## **REMARKS/ARGUMENTS**

**Amendments to the Drawings:**

Appl. No. 10/034,412  
Amdt. Dated Sept. 8, 2004  
Reply to Office Action of April 8, 2004  
Annotated Sheet 3 Showing Changes

*Fig. 4*

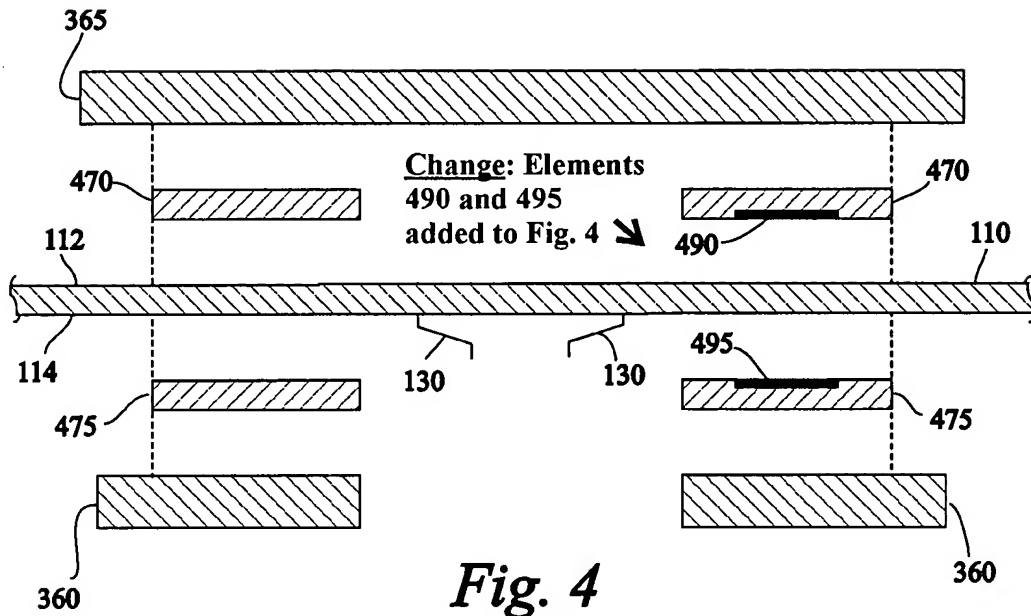
The drawings were objected to as allegedly not showing "means for transmitting energy to said probe card" (claim 1), "an optical sensor" (claims 3 and 8), and "a temperature sensor" (claim 15). Elements 470 and 475, among other elements of the drawings, illustrate examples of "means for transmitting energy to said probe card." Moreover, Figures 4 and 8 are amended to illustrate an example of an optical sensor and a temperature sensor. Therefore, at least one example of "means for transmitting energy to said probe card," "an optical sensor," and "a temperature sensor" are now illustrated in the drawings. Therefore, the objection to the drawings has been overcome.

Attached are two Replacement sheets replacing originally filed sheet 3 (Figures 4, 4A, and 4B) and sheet 8 (Figure 8) of the drawings. On sheet 3, in Figure 4, temperature sensing elements 490 and 495 are added. On sheet 8, in Figure 8, camera 500 is added.

*Fig. 8*

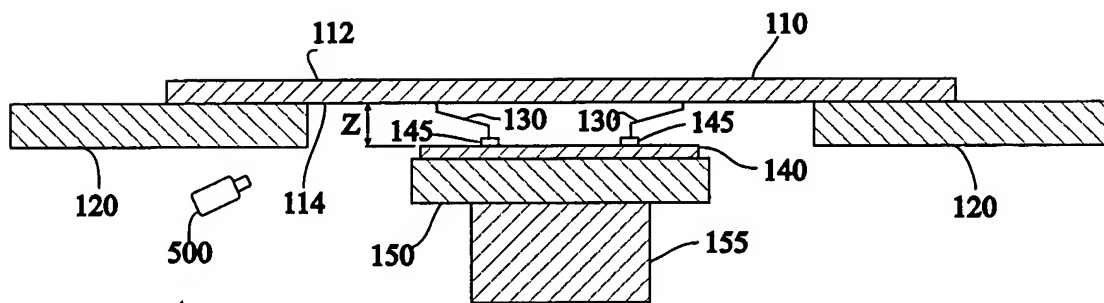
Change: Element  
500 added to Fig. 8
